Mizrahi Intro Written Deputation – on behalf of SFRA

My name is Jordan Max, and I am the Vice President of the Springfarm Ratepayers Association or SFRA, which has been formally registered with the City since 2016. Our boundaries in Ward 5 are from Yonge to Bathurst, and Steeles to Centre, and includes the proposed redevelopment sites. The SFRA is not against redevelopment *per se*. We accept redevelopments that are within the established planning parameters set by the City, and that respect their local context.

Figure 3 - Secondary Plan Height and Density limits for 180 and 100 Steeles Ave West

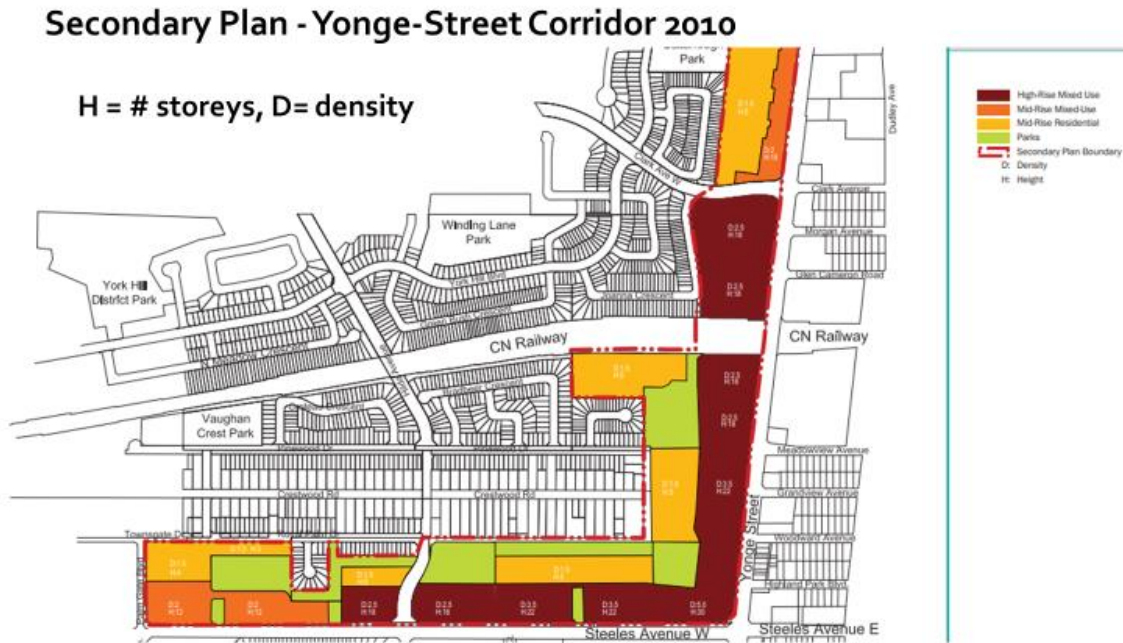
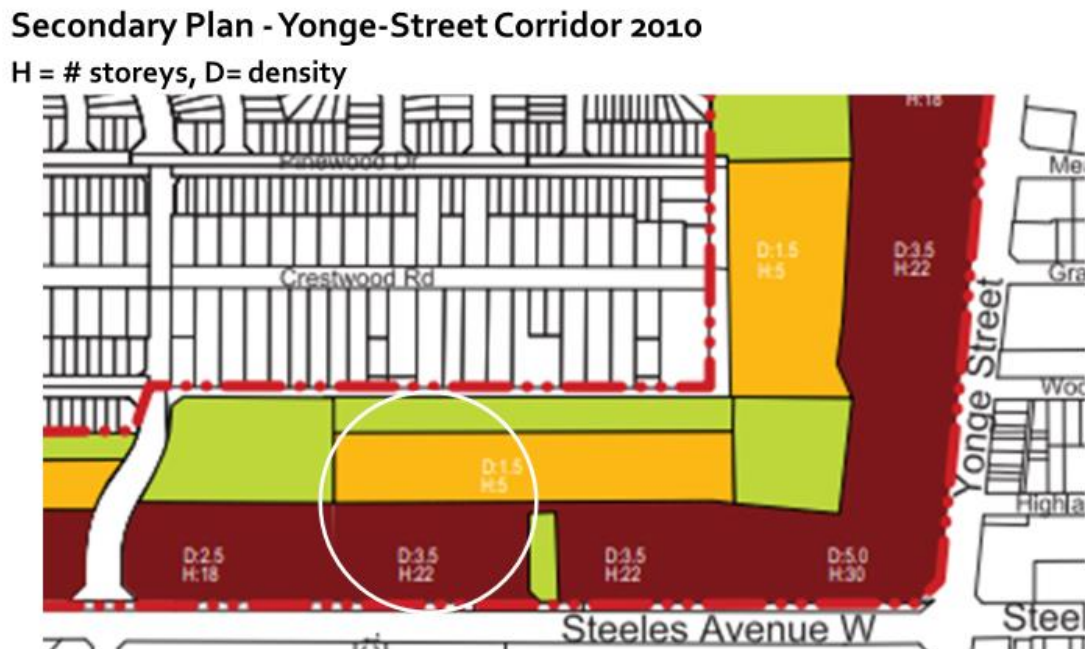
The Secondary Plan allowed for 30 storeys of height for high-rise mixed residential use at the northwest corner of Yonge and Steeles, with office space as a priority, tapering west down to 22 stories (where 180 and 100 Steeles Ave West are), with densities ranging from 5.0 down to 3.5 respectively, and mid-rise residential use of 5 storeys and a density of 1.5 FSI.

The approved Secondary Plan is sufficient and provides a realistic and proportional transition from a single-family neighbourhood to a more urbanized format. It is currently under LPAT appeal by the developers. However, the developer's reports have not provided any quantitative proof that 22 storeys and 3.5 FSI is insufficient to meet local and regional planning objectives.

Since the Secondary Plan was appealed to the OMB in 2010, apparently the uses and limits now revert to OPA 210. Since the OPA 210 precludes residential use, the developer now wants it

both ways: he argues that the Secondary Plan is not in effect, thereby relying on a lower threshold to argue why he needs even greater height and density.
